**CITY OF NAPLES
PURCHASING DIVISION
CITY HALL, 735 8TH STREET SOUTH
NAPLES, FLORIDA 34102
PH: 239-213-7100 FX: 239-213-7105**

ADDENDUM NUMBER 1

NOTIFICATION DATE:	SOLICITATION TITLE:	SOLICITATION NUMBER:	BID OPENING DATE & TIME:
2/5/2021	Lake Restoration & Improvements Project (Lakes 11, 31, & 19) - RFP	21-018	2/19/2021 2:00PM

SHEET TITLE:
NORTH-SOUTH CROSS SECTION DETAIL I - LAKE 31

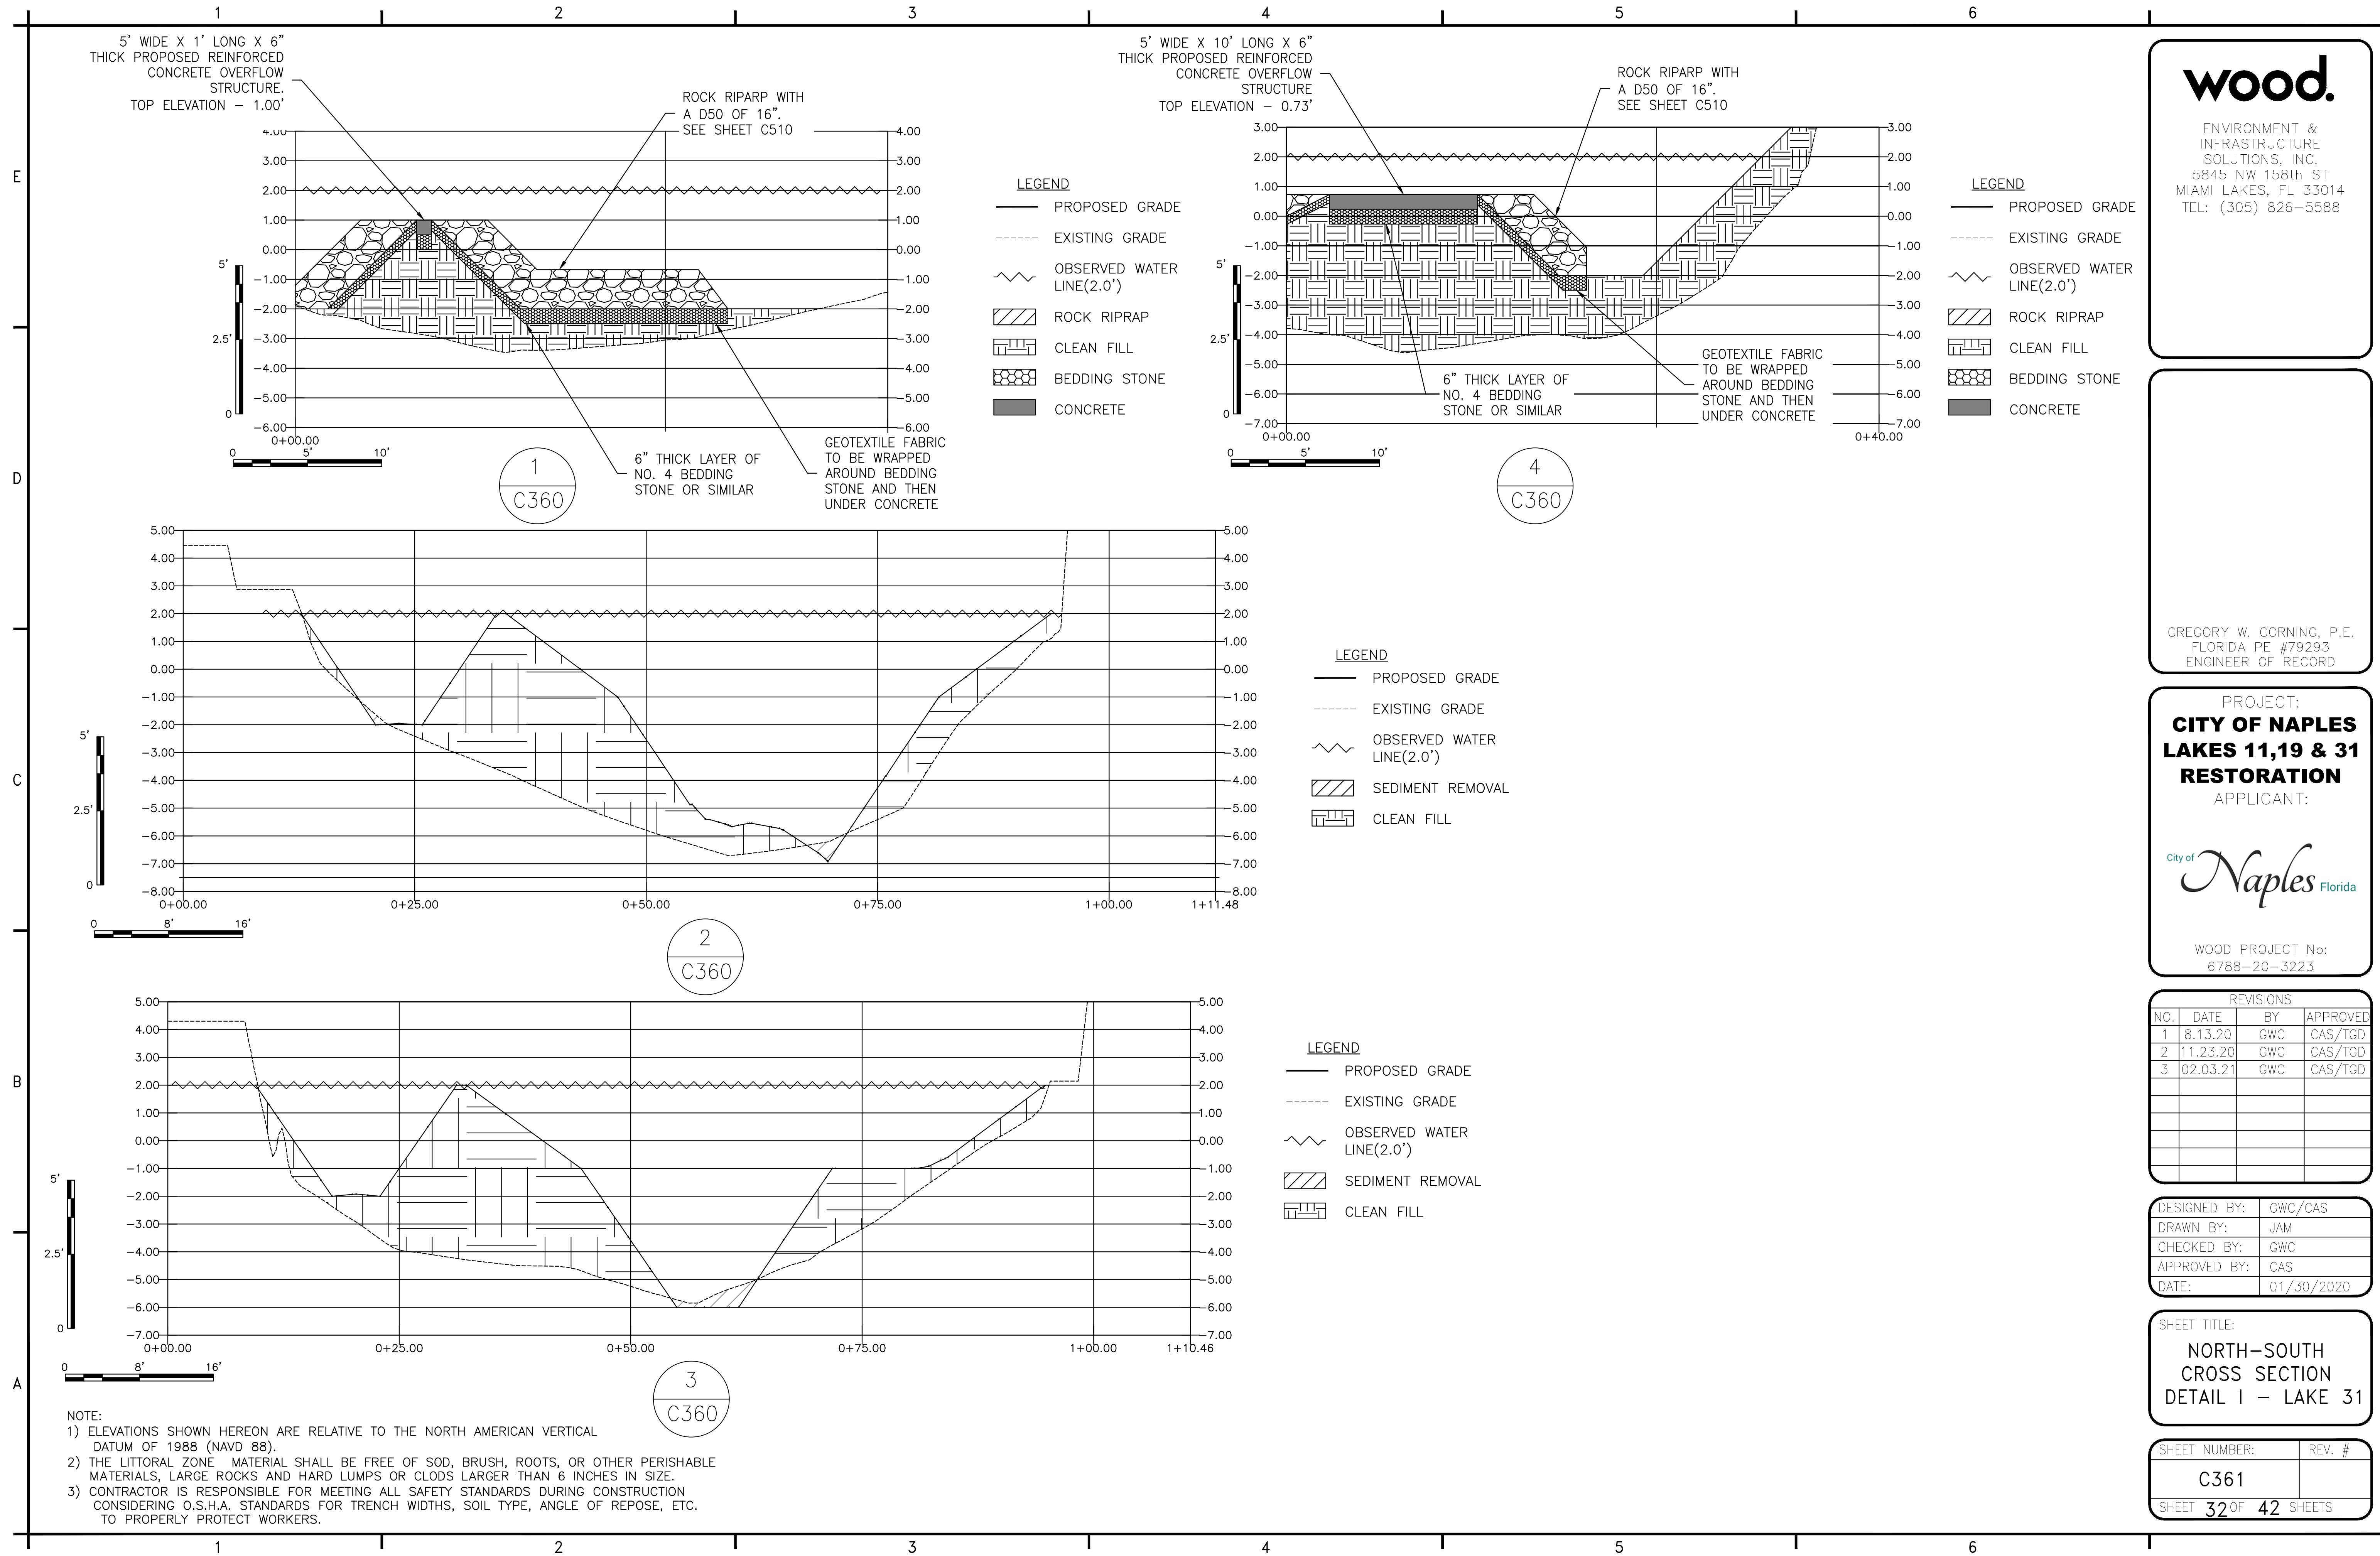
6. On Sheet 9 (lake 31) There are no details provided for either of the concrete weir structures.

ANSWER: On Sheet C223 there are two notes detailing the type of material, slopes, and elevations for each of the structures. Additional cross sections have been added to Sheet C360 and C361 for the concrete weir structures.
